Access Compliance Report Public Rights-of-Way (Pedestrian Signals)

Main Street: ORTEGA_HWY Cross Street: ORTEGA_HWY Location: SE

ADA ID: SGRK211118130544 Signal Type: One Push Button-Non APS Overall Compliance: No Severity Scores: BTN 1: 10 BTN 2: N/A No BTN: N/A

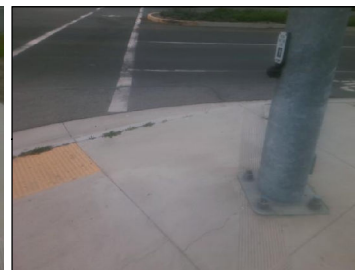
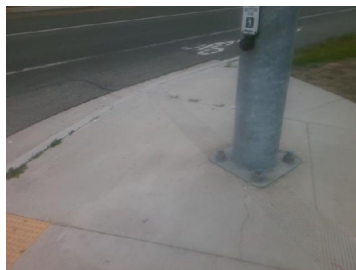
Possible Solutions: Replace Signal Push Button With APS Button. Remove & Relocate Sign.
